ADA ASSESMENT REPORT
COMCARE – NORTHRIDGE FRIENDS CHURCH
2655 N. BULLINGER, WICHITA, KS
Report Date: August 5, 2008

The following ADA site assessment was performed on July 16, 2008 upon request of April Powell, Project Manager for Sedgwick County Project Services.

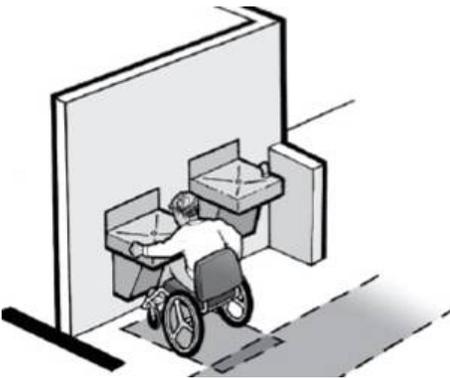
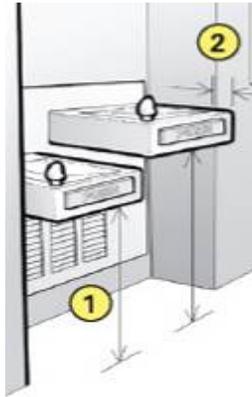
EXISTING CONDITION: Drinking fountain in hallway by kitchen is a protruding object that is not detectable by cane. Objects that project more than 4" from the wall, 27" above the floor and less than 80" above the floor are not cane detectable.

(ADAAG 4.4, 4.15)

RECOMMENDATION: Place a cane detectable object on each side of the drinking fountains. This may be achieved by wing walls or other methods such as those shown below.

Wing walls.

Recessing the drinking fountains such that dimension #2 does not exceed 4".

Figure 703.4.1 Height of Tactile Characters Above Finish Floor or Ground

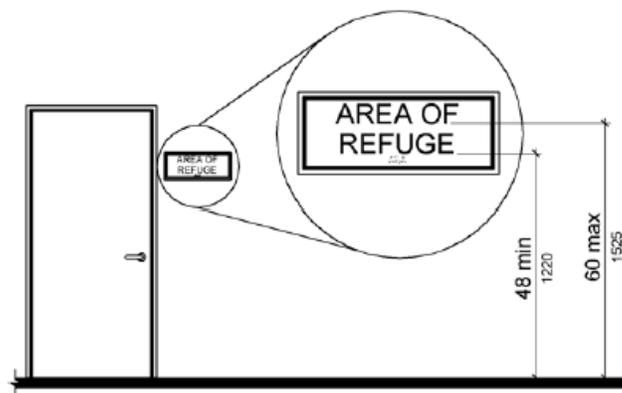
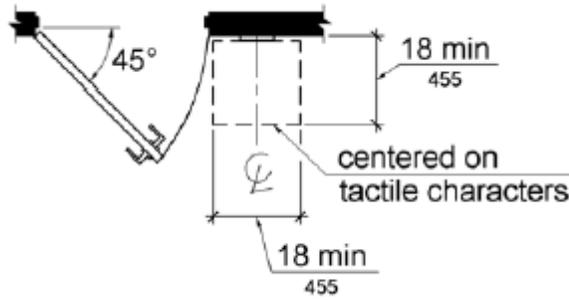
EXISTING CONDITION: Restroom signage is inappropriately located at both the Men's and Women's Restrooms. Signs that identify permanent rooms and spaces (room numbers, exit signs, and restrooms) are required to be provided in Braille, mounted at the latch side of doorway openings. The New ADAAG provides specific guidance on the location of signage. Tactile characters on signs are to be located 48 inches (1220 mm) minimum above the finish floor or ground surface, measured from the baseline of the lowest tactile character and 60 inches (1525 mm) maximum above the finish floor or ground surface, measured from the baseline of the highest tactile character. Where a tactile sign is provided at a door, the sign shall be located alongside the door at the latch side. Signs containing tactile characters shall be located so that a clear floor space of 18 inches (455 mm) minimum by 18 inches (455 mm) minimum, centered on the tactile characters, is provided beyond the arc of any door swing between the closed position and 45 degree open position. (ADAAG 4.1.3(16), 4.30 & New ADAAG 703)

Move signage so that it is located to comply with the new ADAAG. Mount signage so that it complies with the new ADAAG 703.4.1 and 703.4.2. Use the 60" maximum dimension to establish the mounting height.

Figure 604.5.1
Side Wall Grab Bar at Water Closets

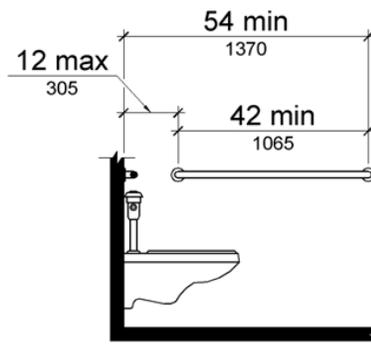
EXISTING CONDITION: The side grab bars at the Men’s and Women’s Restrooms comply with the current ADAAG (at 52”); however, the new ADAAG increases the side grab bar dimension from the back stall wall from 52" to 54" minimum. Per the new ADAAG, the side wall grab bar shall be 42 inches (1065 mm) long minimum, located 12 inches (305 mm) maximum from the rear wall and extending 54 inches (1370 mm) minimum from the rear wall.

(New ADAAG 604.5.1)

Relocate grab bars at this time or immediately upon adoption of new ADAAG (Department of Justice is in its final review period, and imminent adoption is expected).
